**United States Comments on Pedestrian Head and Leg Protection GTR
(INF GR/PS/160)**

The United States of America (US) has reviewed the current revision of the technical rationale for the pedestrian head and leg protection global technical regulation (gtr) (INF GR/PS/160). These comments are based on the requirements of the gtr as outlined in the 1998 Global Agreement (98 Agreement) (see Attachment 1 for applicable sections).

Figure 1
GTR Feasibility – Head Tests
Results

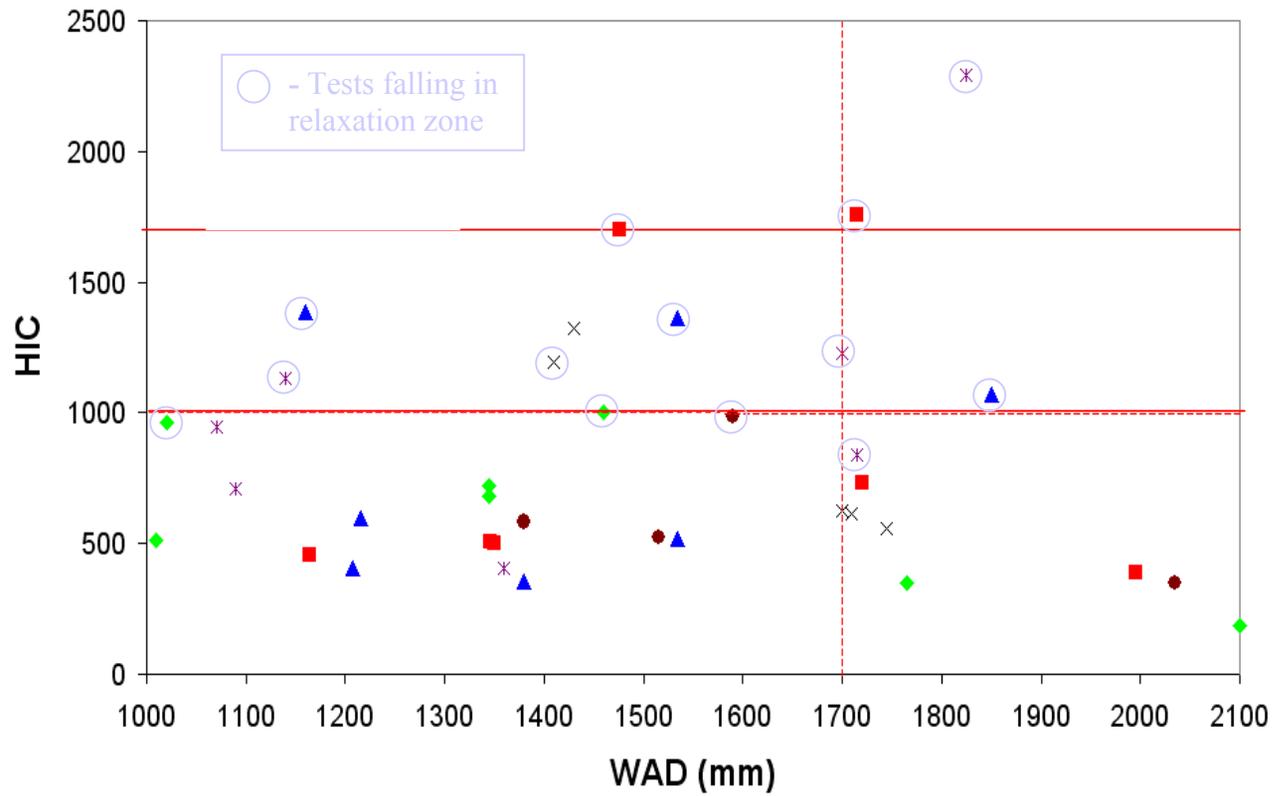
The current gtr (INF GR/PS/160) includes relaxation zones of 1/3 of the windscreen area, 1/2 of the child headform test area, and 1/3 of the combined child and adult headform test areas. In these relaxation zones, the HIC15 limit would be 1700. The US has conducted head impact testing on a cross-section of our own vehicle fleet and we are concerned that applying a relaxation zone with a HIC of 1700 is not stringent enough (see figure 1)¹.

Figure 2
GTR Feasibility - Leg Tests
Results

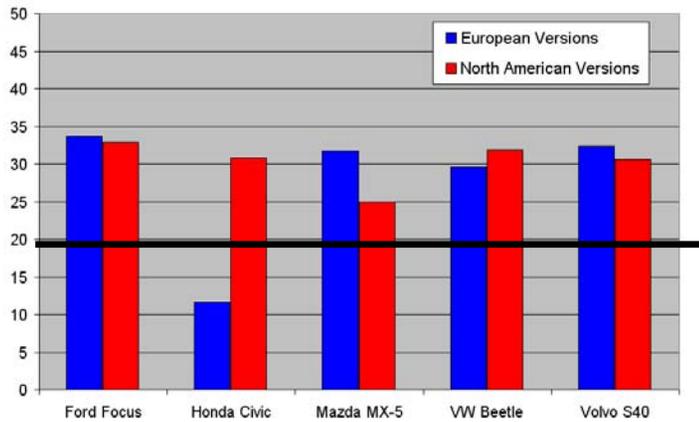
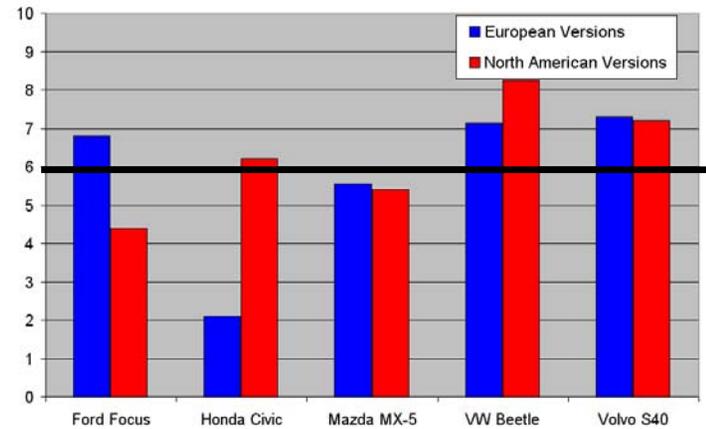
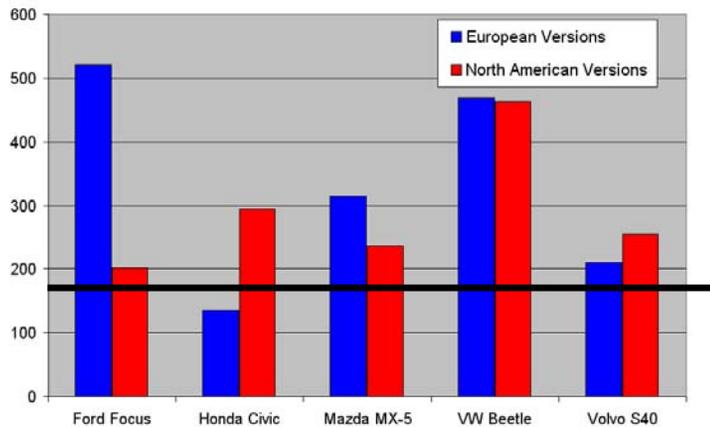
In addition, the US has also conducted preliminary testing to evaluate the US fleet using the lower legform (see figure 2). Further testing is needed to evaluate the fleet using the current gtr requirements. No data has been presented and the US has not conducted any testing with the upper legform, this data is necessary to fully evaluate this requirement.

Out of ten vehicle models examined, only one would meet all 3 GTR requirements (European Civic)
